PCN# : P61DAAB
Issue Date : Feb. 02, 2016

Information Only Notification

Figure 2. Functional Block Diagram

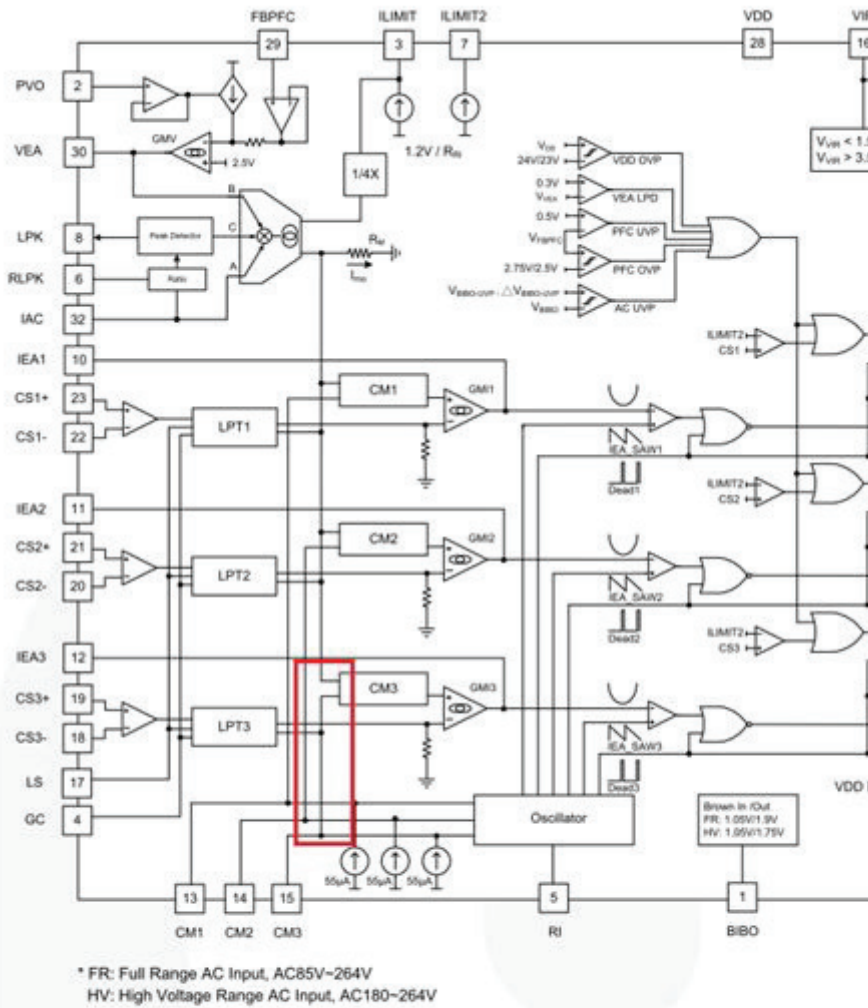
1. Ordering Information only has FAN9673Q (page 1)
2. Functional Block Diagram (Figure 2)

Figure 2. Functional Block Diagram

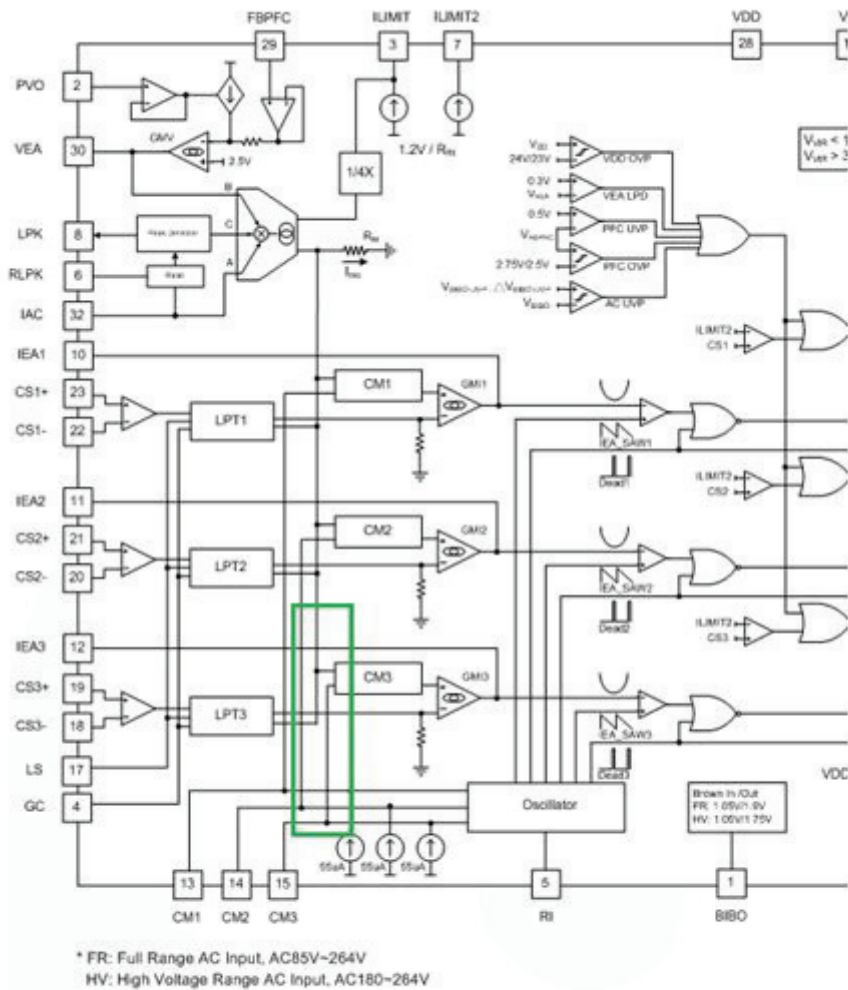
1. Ordering Information, Add new Part Number (FAN9673QX) with Tape and Reel Packing method (Page 1)
2. Functional Block Diagram (Figure 2) Fixed connection wire from LPT3 to CM3 (See attached diagram)

1. Released new part number
2. Corrected typo in Figure 2 drawing
